BEFORE THE PUBLIC SERVICE COMMISSION OF UTAH

In the Matter of the Acknowledgment of)
PACIFICORP Integrated Resource Plan)
2007)

Docket No. 07-2035-01

SUBMITTED BY WESTERN RESOURCE ADVOCATES
On behalf of:

Figure 1 - PacifiCorp Projected CO₂ Emissions (Avg. of CO₂ Adder Cases)

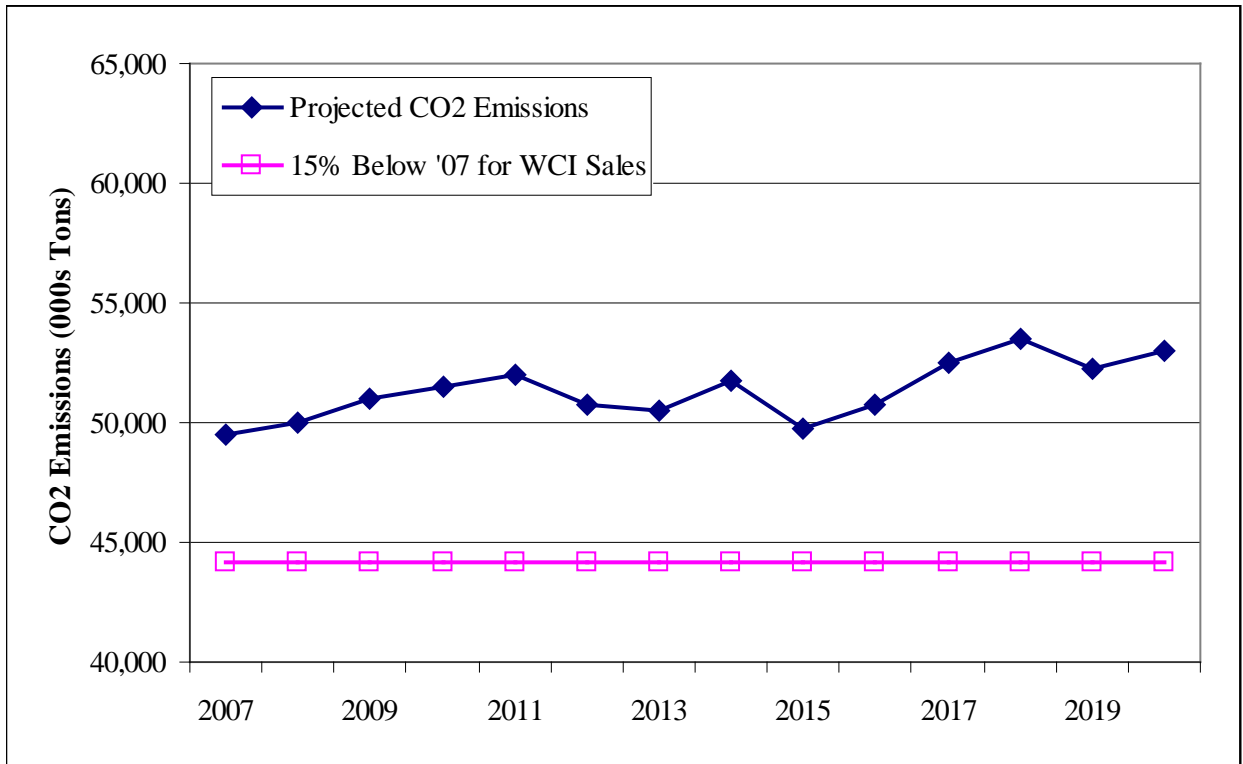
Figure 1 depicts PacifiCorp's projection of CO₂ emissions for the proposed IRP portfolio (RA14). PacifiCorp projects total CO₂ emissions increasing from approximately 49.5 million tons in 2007 to 53.0 million tons in 2020, an increase of 7.1%. Assuming PacifiCorp is required to make a 15% reduction in its CO₂ emissions associated with sales to WCI-member states, its CO₂ output needs to be held to approximately 44,150 thousand tons of CO₂, depicted by the pink line in Figure 1.⁴

To meet the general target assumed in the figure above, PacifiCorp will be required to reduce or offset, in some manner, at least 8.85 million tons of CO₂ per year, or roughly 17% of its CO₂ footprint by 2020. At a cost of \$30/ton of CO₂, PacifiCorp’s carbon profile will cost its customers an additional \$265 million per year. This value is obviously rough, but for a variety of reasons, fairly conservative. If, for example, we assumed the \$30/ton allowance value increases at a 2.5% rate of inflation and we assume Wyoming joins the WCI, PacifiCorp’s 2020 emission allowance risk could be as high as \$423 million per year.

Figure 2 – Coal Prices Delivered to Utah Industries

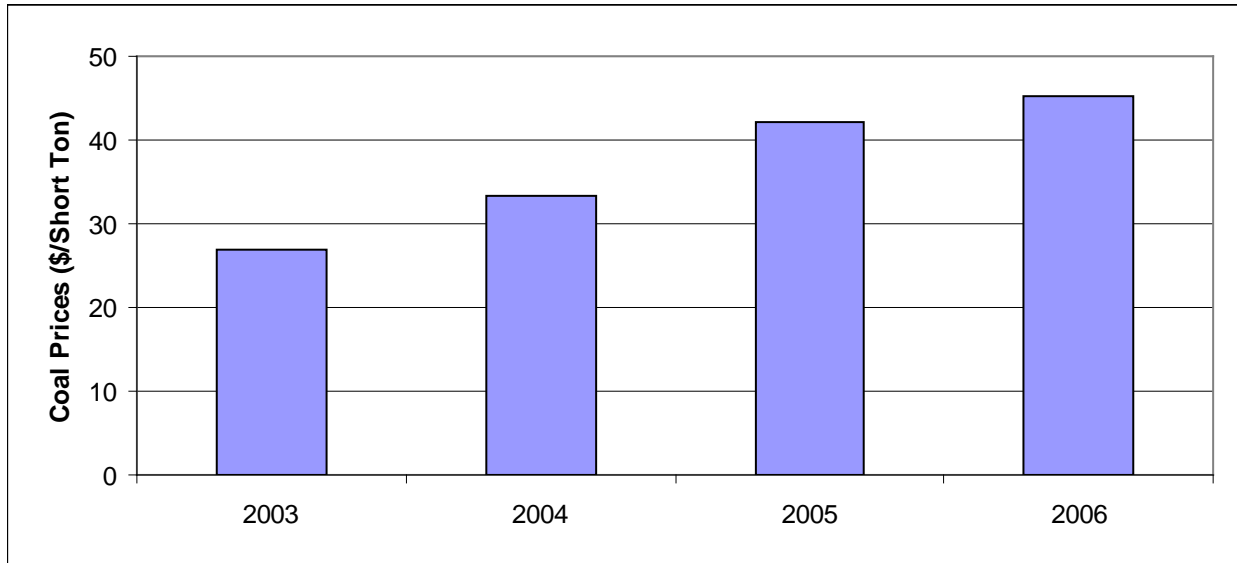
PacifiCorp's IRP fails to assign realistic price volatility risk to coal as a fuel source. The Company's analysis assumes coal costs will escalate approximately 4% per year. The high value incorporated in 4 of 16 alternative future scenarios include a high value which adds a 20% premium to the reference forecast. In recent past, however, coal prices have been extremely volatile. From 2003 to 2006, coal prices in Utah have increased 68%.¹⁶ See Figure 2. We believe the volatility inherent in the coal markets has been downplayed by PacifiCorp in its application of the models.
